Accessibility Design Review Report - DA

Project Title: RFBI Benhome Aged Care Facility
30 Regent St, Maitland

Report Version: 24104_ADR_DA_v1.3

Figure 1 – Ground Floor plan extract

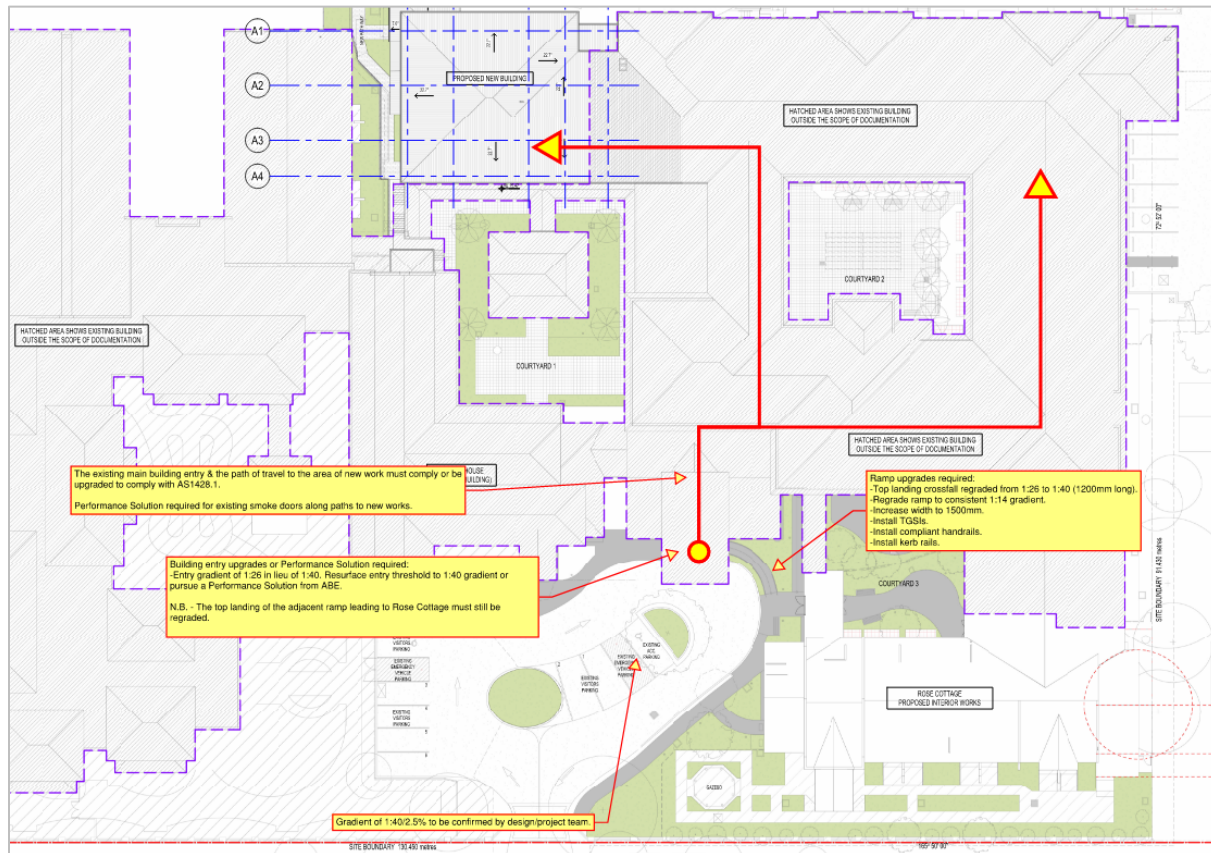
Arrows – Indication of the Principal Pedestrian Entrance & “affected part” paths of travel.

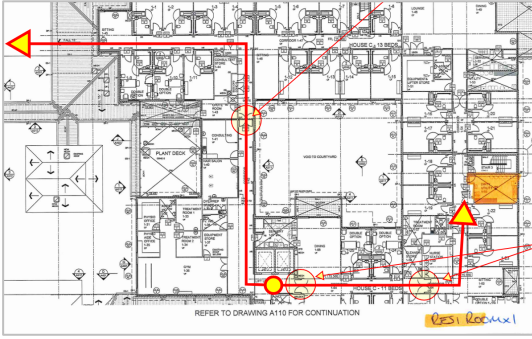
Requirements	Comment(s)/Recommendation(s)	Status
The Principal Pedestrian Entrance and in some cases the pathway leading to it are required to comply or be upgraded to comply with the accessibility provisions and standards listed in Section 1.	<p>The building has 1x existing entry being assessed for the purposes of this development (Figure 1 yellow circle).</p> <p>It has been determined that a new entry to Rose Cottage will be provided, and this will be assessed in addition to the existing entry to satisfy the Premises Standards.</p> <p>The following associated compliance issues are required to be upgraded as a condition of undertaking the proposed works. Refer to the below and attached mark-ups for necessary upgrades.</p> <ul style="list-style-type: none"> Entry call button/intercom needs to be relocated between 900mm - 1250mm AFFL. 	CoC/ PSR

- The buildings entry has an external landing area gradient of 1:26 in lieu of 1:40. Stakeholders have requested ABE provide a Performance Solution to address the existing gradient. This will be subject to the condition that the landing to the adjacent ramp leading to Rose Cottage is resurfaced to 1:40.

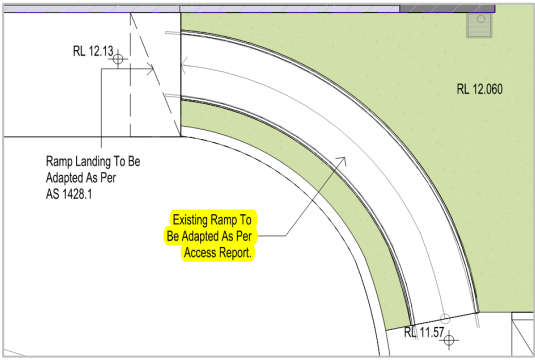
Requirements	Comment(s)/Recommendation(s)	Status
<p>The pathway from the nominated Principal Pedestrian Entrance(s) to the area(s) of new works are required to comply or be upgraded to comply with the accessibility provisions and standards listed in Section 1.</p>	<p>There are several accessible pathways related to the proposed development.</p>  <p><i>Example of affected part in existing corridors.</i></p> <p>Refer to the below and attached mark-ups for necessary upgrades.</p> <ol style="list-style-type: none"> The external ramp between the building entry and Rose Cottage must undergo the following upgrades. <ol style="list-style-type: none"> Top landing crossfall regraded from 1:26 to 1:40 (1200mm long). Regrade ramp to consistent 1:14 gradient. 	<p>CoC/ PSR</p>

<p>iii. Increase width to 1500mm. iv. Install TGSIs. v. Install compliant handrails. vi. Install kerb rails.</p>  <p>2. Active leaf of existing double doors leading to areas with proposed works measured clear openings less than 850mm wide. Performance Solution to be pursued.</p> <p>3. Lack of luminance contrasting to existing doorways. Performance Solution can be pursued.</p>	
--	--	--

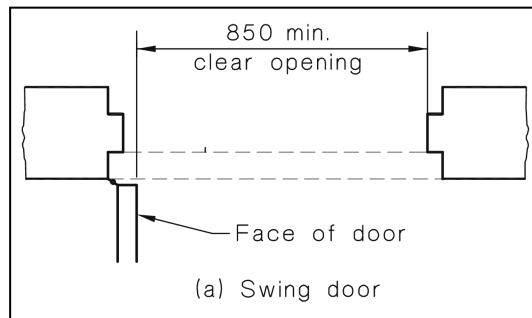
1x Accessible SOUs is required to be provided as part of the 4x new units.

An accessible SOU requires AS1428.1 circulation space to all rooms/areas & Acc WC + Shower.

A Performance Solution can be pursued to address the reduction/omission of accessible SOUs.

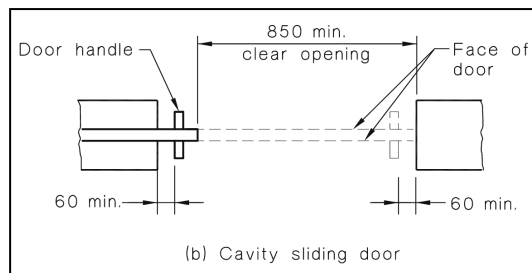
All doorways along an accessway are required to have a clear door opening width no less than 850mm clear (to the active leaf) and be provided with door circulation spaces as prescribed by AS1428.1-2009.

Ensure hardware clearance of **60mm either side** is provided to sliding doorways in the open/closed position.

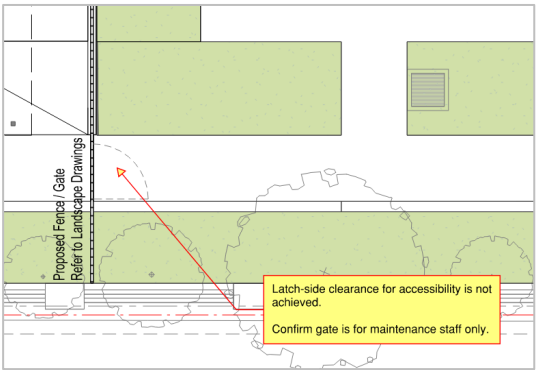
<p>It is assumed that the below proposed gate outside Rose Cottage will be for maintenance staff use only.</p> 	
--	---	--
